KD8 (-B) Modular Door Station V2.2.58_build220725

Release Note (2022-08-02)

Firmware Basic Information	Firmware Version	V2.2.58_220725
	Device Type	(2022-08-02): DS-KD8003-IME1(B) DS-KD8003-IME1(B)/Surface DS-KD8003-IME1(B)/Flush (2022-08-23): DS-KD8003-IME1(B)/S DS-KD8003-IME1(B)N/S
	Device Type (Kits)	(2022-08-02): DS-KIS602(B)

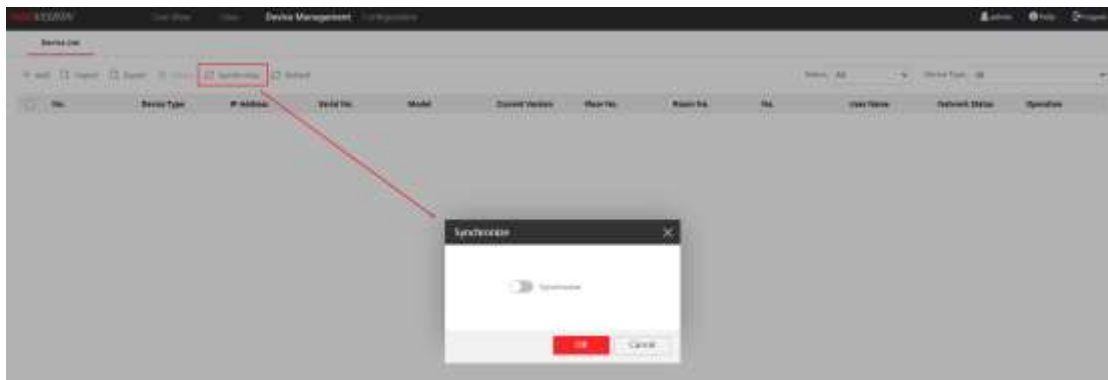
2.4 The public password supports opening specified lock(lock 1 or 2)

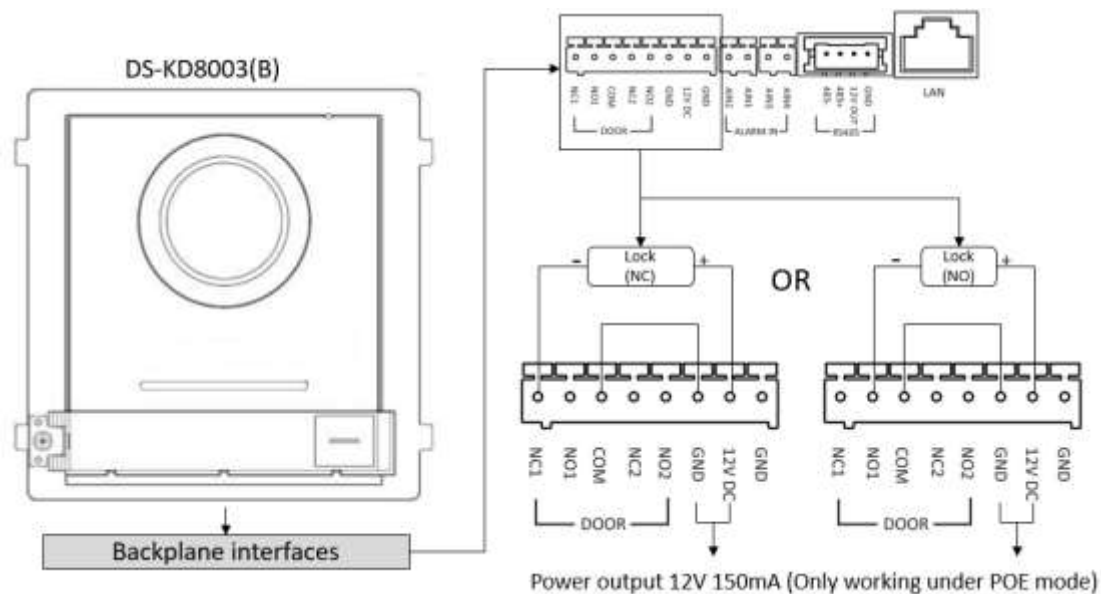
2.5 The Synchronization switch in Device Management interface is Off by default.
